**RE: 16951 Placer Oaks Road**

I reviewed the drawings and evaluated the neighborhood context. My comments and recommendations on the design are as follows:

*Proposed Streetscape: Same Side*

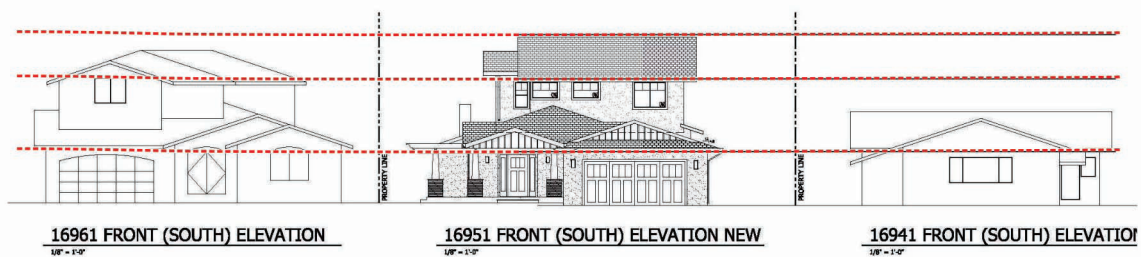
The proposed project would retain the existing front facade and the second floor addition set back substantially from the front facade - see illustration below.

First and second floor eave heights would be comparable to other two story homes in the immediate neighborhood - see illustration below.

There are two other homes with partial second floors in the immediate neighborhood. The proposed second floor facade would be set back further from the street than either of the other second stories in the immediate neighborhood - see illustration on the following page.

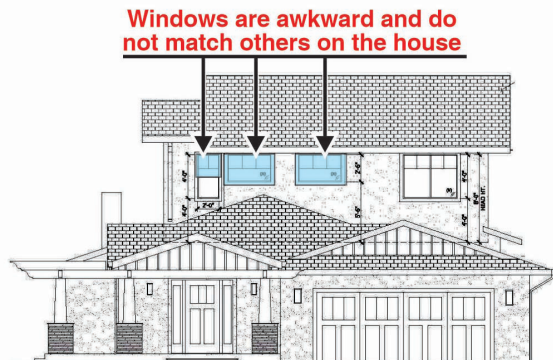
The visual impact on the streetscape would be comparable to the home two parcels to the right and should be negligible - see photo below,.

1. Three of the second floor windows on the front facade are quite different for all of the other windows in the house and are not typical proportions for the proposed architectural style.
